UNITED STATES PATENT AND TRADEMARK OFFICE

APPLICATION NO.	FILING DATE	FIRST NAMED INVENTOR	ATTORNEY DOCKET NO.	CONFIRMATION NO.
09/769,727	01/26/2001	Robert J. Ein	035887-0106	5192

Office Action Summary

DETAILED ACTION

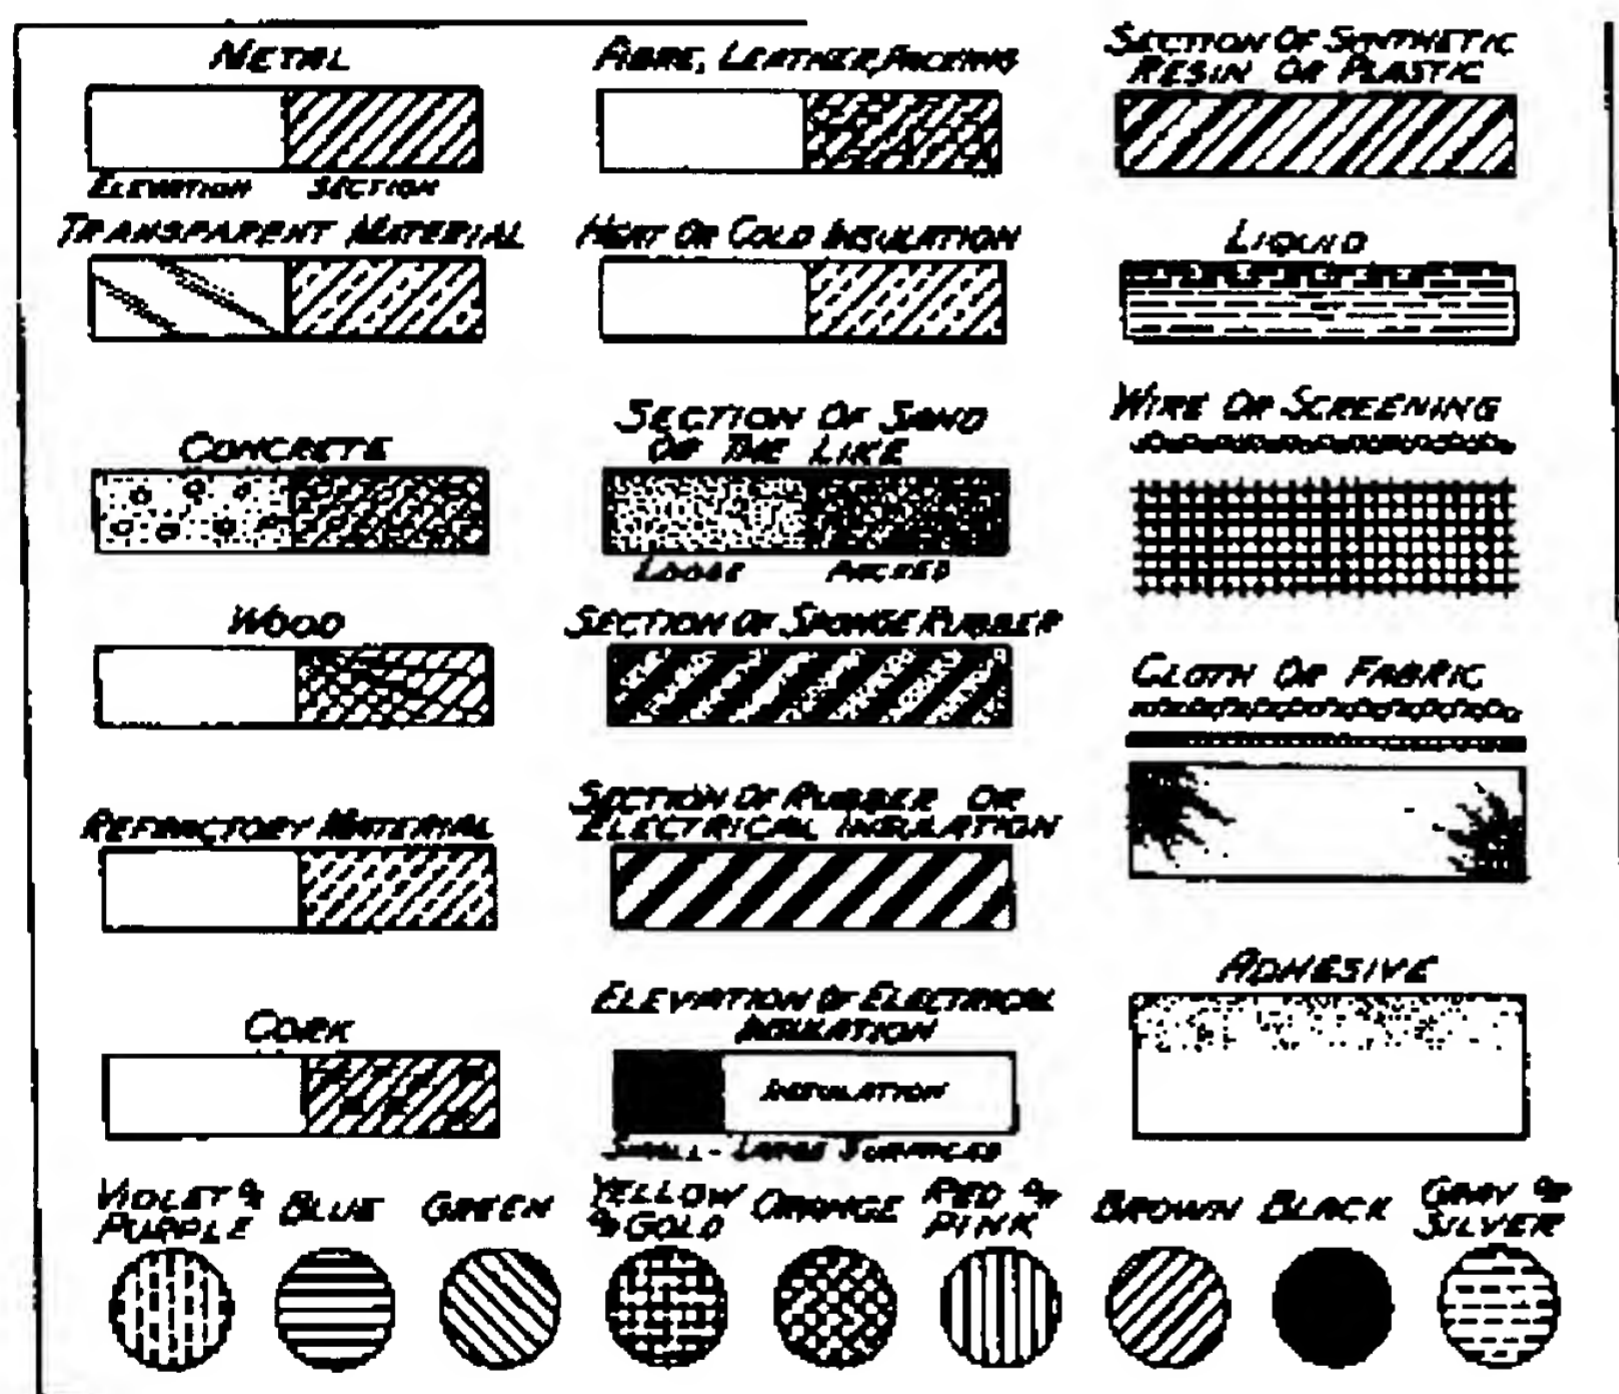
The drawings are objected to because of the following informalities:

Fig. 4A-4E: Proper cross-sectional hatching is required to properly denote insulative and metallic materials in accordance with MPEP 608.02 (see the drawing below for proper hatching examples).

The response to this action must include a separate letter addressed to the examiner and contain: (1) sketches showing in red the drawing changes required above and (2) a request that the examiner approve the changes as shown on the sketches.
